System Impact Assessment Report
Erie Shores Wind Development Project
Applicant: **AIM PowerGen Corporation**

CAA ID 2003-106

April 20, 2005

System Impact Assessment Report

FIGURE 1 : PROPOSED CONNECTION

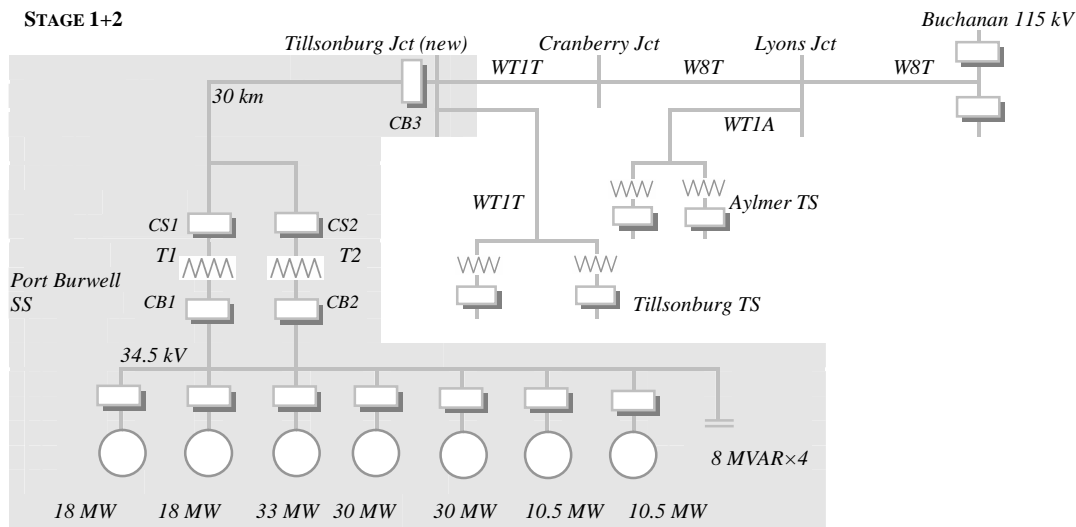
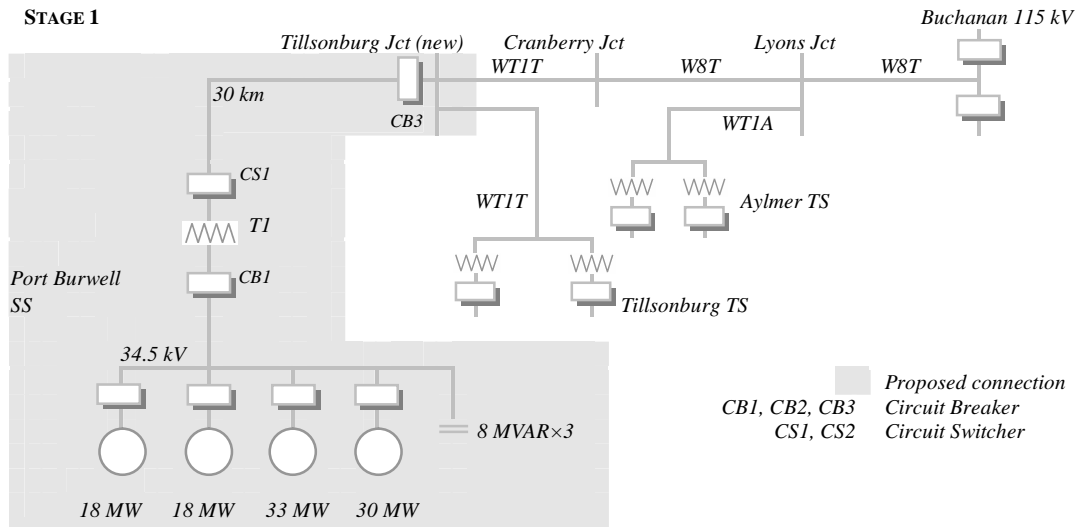
The first stage is to develop a 99 MW generation facility consists of sixty six GE1.5 MW, 575V induction generators. They will be connected to four 34.5 kV feeders (W1, W2, E1 and E2) using individual tower-base mounted 1.7 MVA, 34.5 kV/600 V transformers. These four feeders will be connected to a common 34.5 kV collector bus bar via 1200 A, 20 kA circuit breakers and disconnect switches. This 34.5 kV collector bus bar will be connected to the 115 kV circuit WT1T using a single 75/100/125 MVA (ONAN/ONAF/ONAF), 115/34.5 kV transformer T1, two circuit breakers CB1, CB3 and a circuit switcher CS1 as shown in Figure 1.

The second stage is to develop a 51 MW generation facility consists of thirty four induction generators of same type as used in stage 1. They will be connected to three new 34.5 kV feeders (W3, E3 and E4). These three new feeders will also be connected to the same collector bus from stage 1. A new 115/34.5 kV transformer T2 with ratings 35/50/60 MVA (ONAN/ONAF/ONAF), a circuit breaker CB2 and a circuit switcher CS2 will be connected between the collector bus and the 115 kV bus at Port Burwell SS as shown in Figure 1.

However, the IESO Transmission Assessment Criteria state that new or modified facilities must not reduce the existing level of reliability of existing facilities. Specifically, if the new connection increases the fault exposure of the existing system significantly, it is necessary to install new circuit breakers to separate protection zones to eliminate the additional exposure. Thus, the originally proposed circuit switcher at new Tillsonburg Junction will have to be replaced with a circuit breaker CB3 as shown in Figure 1.

This breaker must be rated as follows:

- Maximum Operating Voltage – 127 kV
- Rated Interrupting Time – 5 cycles or less
- Short circuit symmetrical duty – 50 kA

It is required that a 115 kV breaker be installed at the point of connection of the new 115 kV line to the existing IESO-controlled grid. The breaker is required to be rated for continuous operation at 127 kV and have a short current interrupting capability of 50 kA.

FIGURE 2 – STANDARD FOR SETTING UNDER-FREQUENCY TRIP PROTECTION FOR NEW GENERATORS

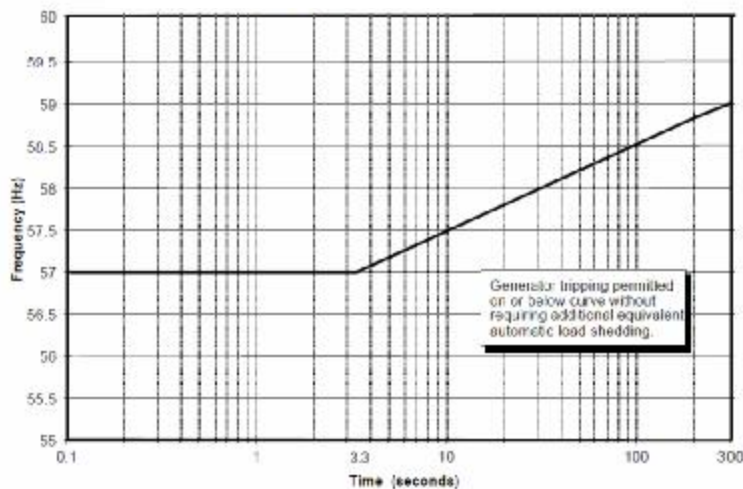
Appendix 4.2 of the Market Rules requires that generators be able to operate continuously at available active power output for system frequencies between 59.4 to 60.6 Hz. For under-frequency system conditions, the generators shall not trip for frequency variations that are above the curve shown in Figure 2.

7. It is required that for under frequency system conditions the generators must not trip for frequency variations that are above the curve in Figure 2 of this report.

FIGURE 3 – VARIATION OF DFIG TERMINAL VOLTAGE

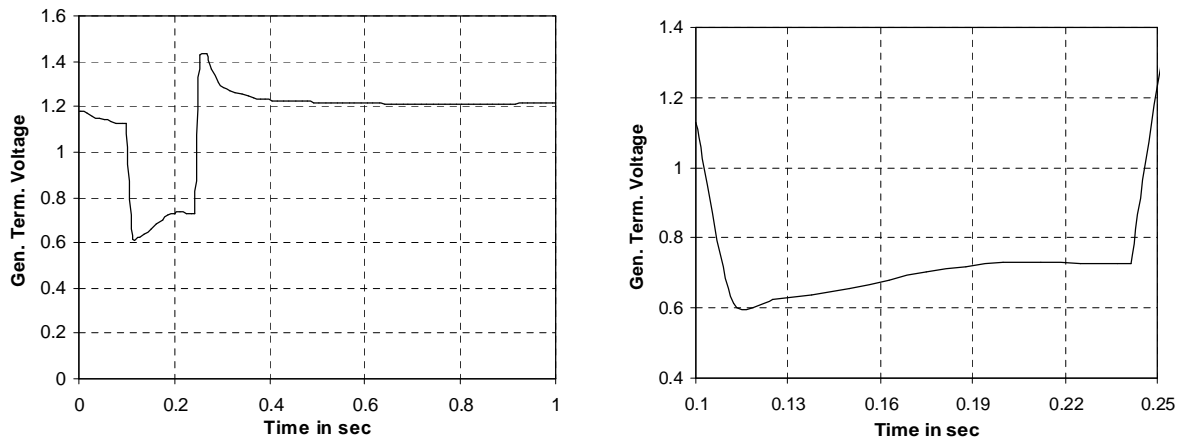
In order to examine the need for low voltage ride through capability for the 100 MW development, the IESO simulated a LLG fault at Buchanan 115 kV bus which was cleared in 140 ms which corresponds to 5 cycle breakers available at Buchanan 115 KV system. The variation of the 34.5 kV terminal voltage of the DFIGs is plotted below for 0-1 sec and 100-250 ms. The 100-250 ms plot shows the duration during which the generator terminal voltage drops below 0.7 pu where without the LVRT, the generators would immediately trip by under-voltage protection.

Simulation results show that the 100 MW development must be equipped minimum with Level I of LVRT capability to remain connected to the IESO-controlled grid. It must be emphasized that the IESO has observed inaccuracies in the available PSS/E dynamic model for induction generators and consequently, the conclusions on LVRT capability requirement drawn from transient simulations are not necessarily accurate or dependable.
